YUCCA MOUNTAIN - REQUEST FOR ADDITIONAL INFORMATION - SAFETY
EVALUATION REPORT, VOLUME 3 - SET 1 FOR EACH OF THE FOLLOWING
POSTCLOSURE CHAPTERS 2.2.1.4.1, 2.2.1.4.2, AND 2.2.1.4.3.

RAI Volume 3, Chapter 2.2.1.4.1, First Set, Number 1:

Response Tracking Number: 00488-00-00

RAI: 3.2.2.1.4.1-001

Figure 1. Expected Fraction of Commercial SNF Waste Packages Failed by Stress Corrosion Cracks in the Closure Welds: 1,000,000-Year Seismic Ground Motion Modeling Case

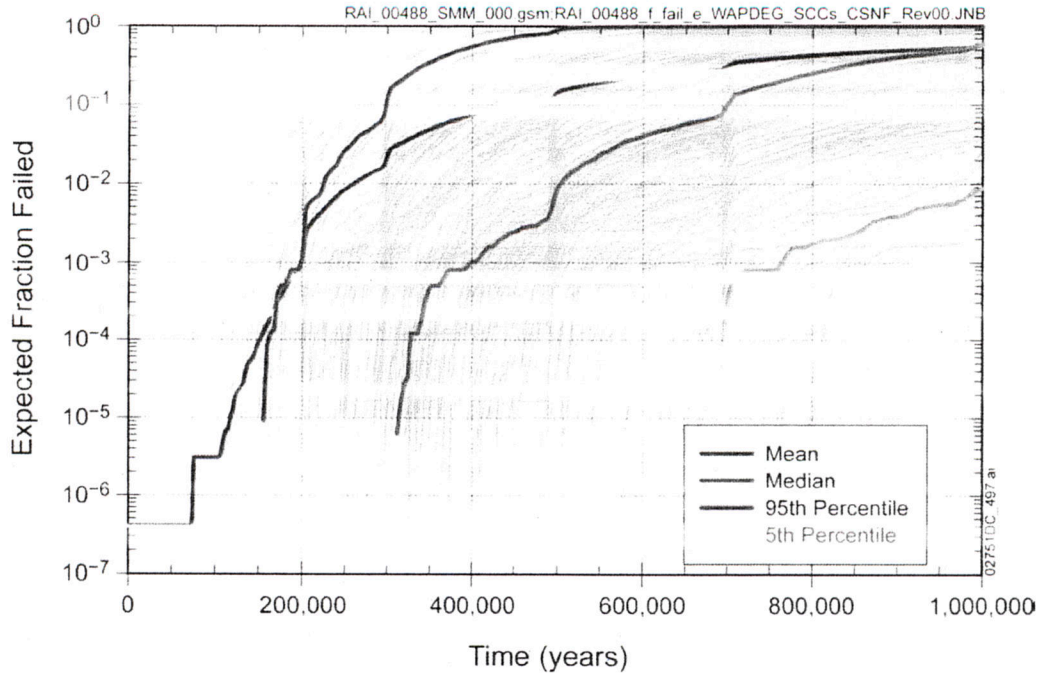
For the combined seismic and nominal model case provide the fraction of waste packages breached, and the area damaged by (i) stress corrosion cracking, (ii) puncture and rupture, and (iii) general corrosion. Provide all these waste package fractions and damaged areas as functions of time for both commercial spent nuclear fuel and co-disposal packages. This information is needed to determine compliance with 10 CFR 63.114.

Figure 1 shows the expected fraction of commercial SNF waste packages that fail with at least one stress corrosion crack in the closure welds. Waste packages with stress corrosion cracks in the closure weld may also have damage from general corrosion, seismic ground motion-induced stress corrosion cracks, and seismic ground motion-induced ruptures or punctures that is not included in the results shown in Figure 1. The 300 histories shown in Figure 1 characterize the uncertainty in the expected fraction of waste packages that have stress corrosion cracks in the closure welds. The expected failure fraction for each epistemic realization is the average result
